To: T10 Technical Committee  
From: Rob Elliott, HP (elliott@hp.com)  
Date: 21 April 2004  
Subject: 04-115r0 SAS-1.1 Miscellaneous changes

sas1r04 - Serial Attached SCSI 1.1 revision 4

**Figure 1 — Expander device [updated figure 12]**

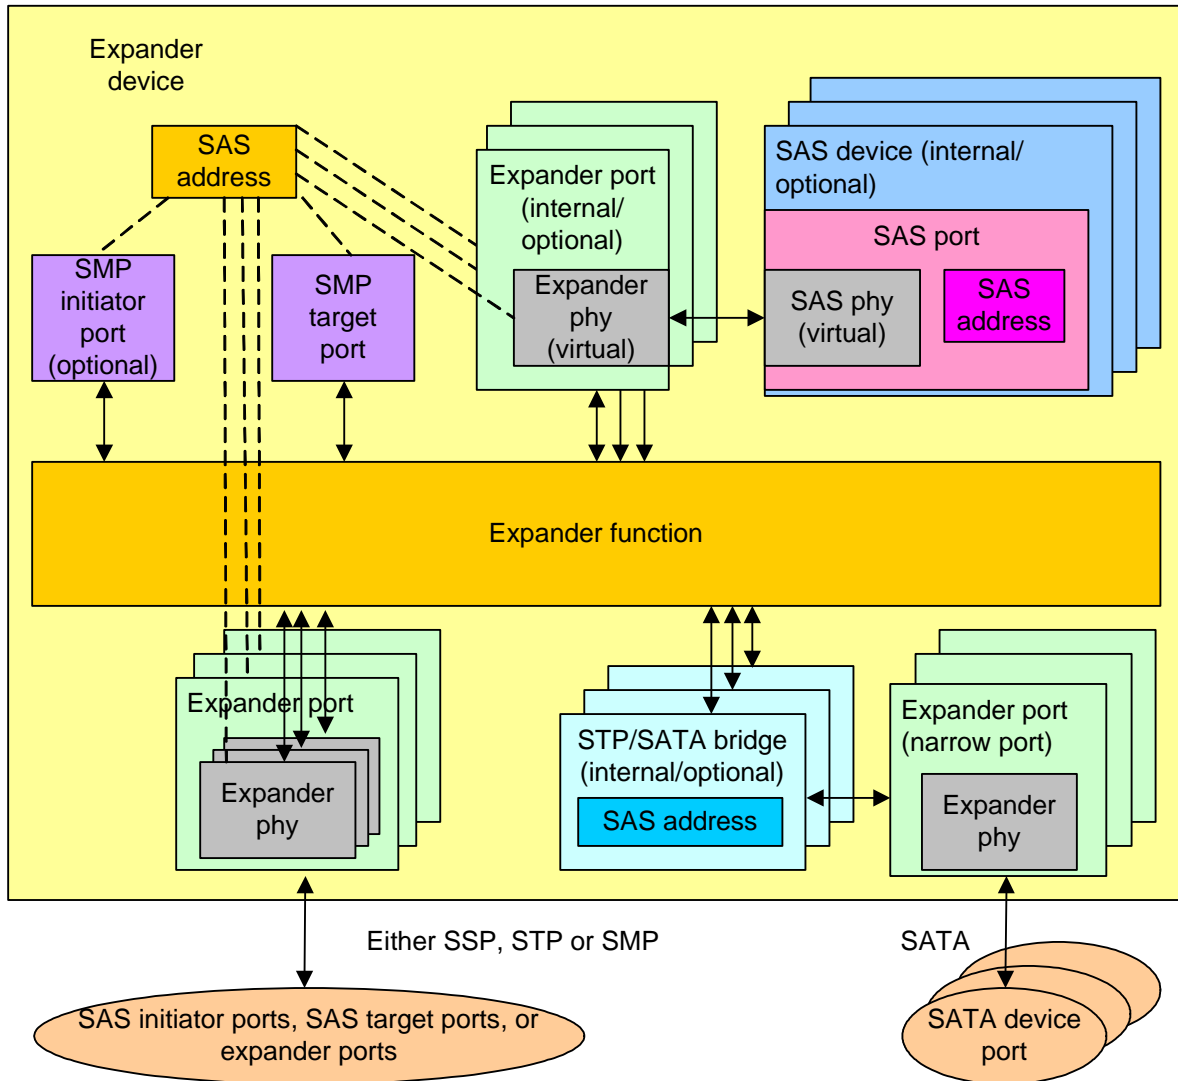
**2 Clause 4 - add SMP initiator port to figure 12**

Add an optional *SMP initiator port* to figure 12, since if present it shares the expander's own SAS address with the *SMP target port*. Also add some more phys to the ports in the picture and show the SAS addresses.

**Figure 4 — Transmitting a continued primitive sequence [figure updated]**

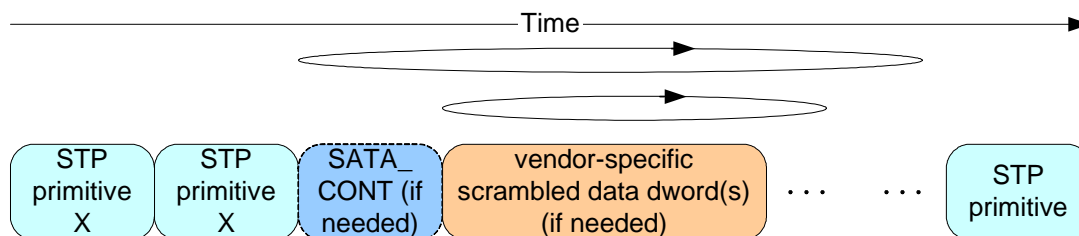
7.2.4.3 **Repeated Continued primitive sequence**

Primitives that form **repeated-continued** primitive sequences (e.g., SATA\_HOLD) shall be **sent** **transmitted** two times, then be followed by SATA\_CONT (if needed), then be followed by vendor-specific scrambled data dwords (if needed). ALIGNs and NOTIFYs may be sent inside **continued** primitive sequences as described in 7.2.4.1. After the SATA CONT, during the vendor-specific scrambled data dwords:

Figure 4 shows an example of **transmitting** a **repeated continued** primitive sequence.

Figure 6 — Transmitting a continued primitive sequence [\[figure updated\]](#)

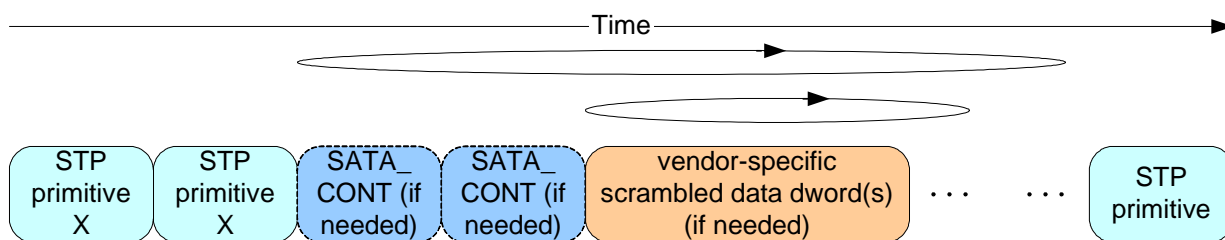
## 10 Clause 7.2 - allow sending two SATA\_CONTs

In SAS, mention that STP ports may send two SATA\_CONTs rather than one to survive a single bit error in SATA\_CONT.

Figure 6 shows an example of transmitting a continued primitive sequence [with two SATA\\_CONTs](#).

Editor's Note 1: as as, the transmit picture from the previous proposal allows for this (assume it loops on (SATA\_CONT followed by data dwords) where no data dwords are included) so updating the picture might not be necessary.

Figure 103 — STP target port opening an STP connection [\[modified\]](#)

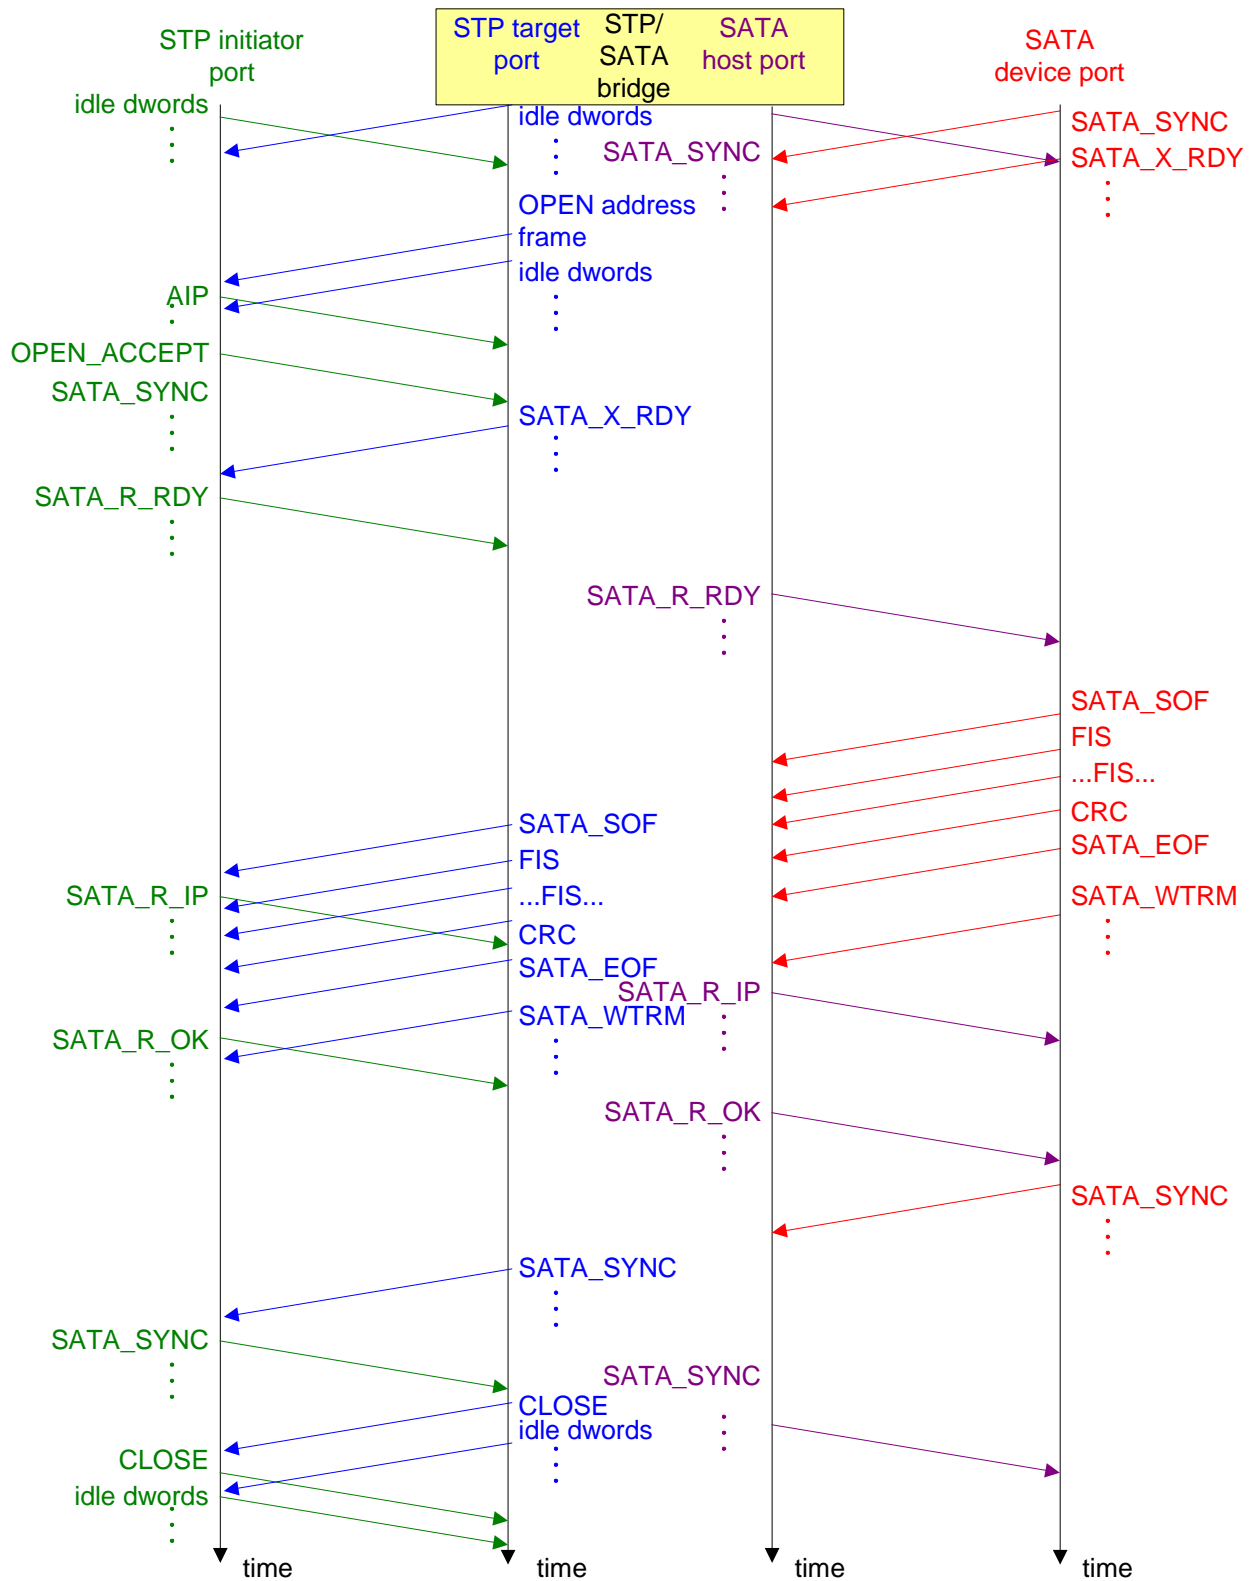
Figure 103 shows after sending OPEN\_ACCEPT, an STP initiator continues to send idle dwords before sending SATA\_R\_RDY. Section 7.17.8 explicitly allows this.

Also, redraw figure 103 so it flows left to right rather than right to left.

[\[changed idle dwords to SATA\\_SYNC in what is now the top left\]](#)
